HORSHAM DISTRICT COUNCIL CONSULTATION

TO:	Horsham District Council – Planning Dept
LOCATION:	New Place Nurseries London Road Pulborough West Sussex
DESCRIPTION:	Reserved Matters application pursuant to Outline Planning Consent DC/21/2321, as varied by application DC/24/1204. The Reserved Matters comprise details of 160 no dwellings, associated internal access roads, parking and landscaping for areas east of the right of way. Details of appearance, landscaping, layout and scale to be considered.
REFERENCE:	DC/24/1676
RECOMMENDATION:	Objection/Recommendations & Advise
SUMMARY OF COMMENTS & RECOMMENDATION: Bin Collection Point Amendments	
MAIN COMMENTS: Objection to latest plans: H9376-GPA-XX-XX-DR-UD-203007-C03-Refuse Strategy Plan Attached below are amended bin collection points for various dwellings/plots. The original refuse strategy has the resident drag distance lines in orange, and the collection points with a blue dot. HDC's amended refuse strategy has purple lines that represent the resident drag distance, and yellow dots being the collection points. Section 46 of the Environmental Protection Act 1990 sets out council requirements regarding waste and recycling collections. T

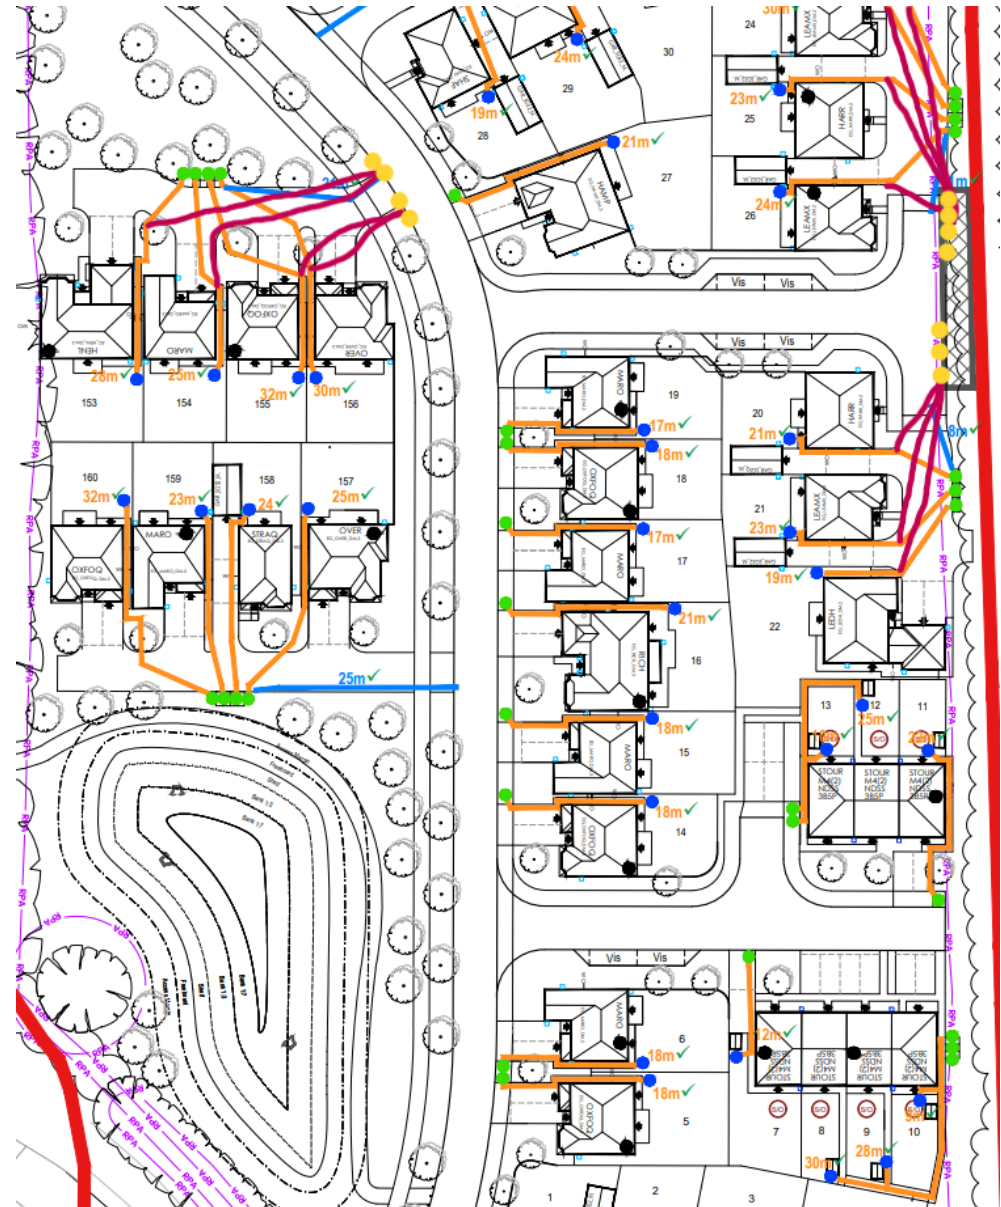
PLOTS: 20,21,22 / 23,24,25,26 / 153,154,155,156

BIN COLLECTION POINT AMENDMENTS: PLOTS: 34,35,36 / 60,61 / 67,68,69,70
